## **DRAFT NOTES**

### **7<sup>th</sup> meeting of GRVA MVC IWG on Modular Vehicle Combinations**

**6. Review draft proposal for amendment of R13**

### Paragraph 5.1.3.6.3.

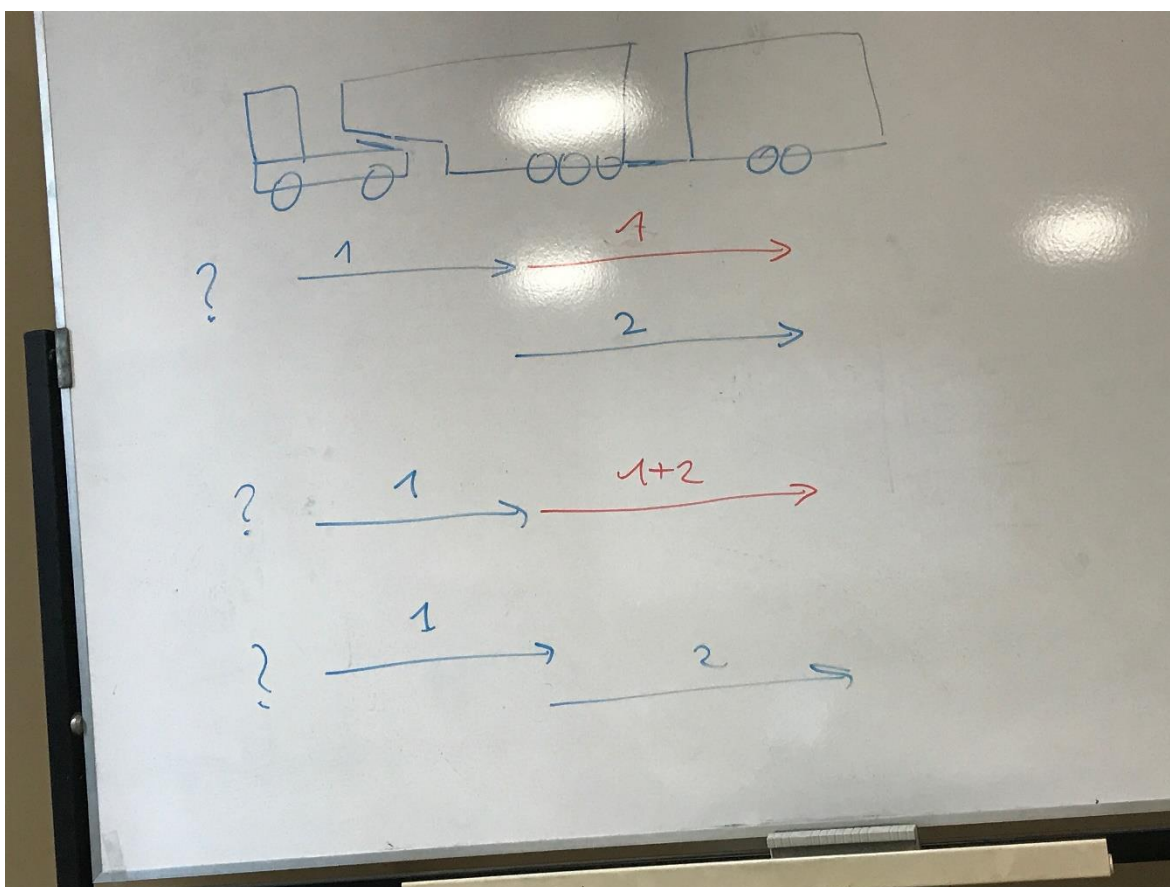
Deletion of the last part of the 1<sup>st</sup> paragraph: due to that it is redundant.
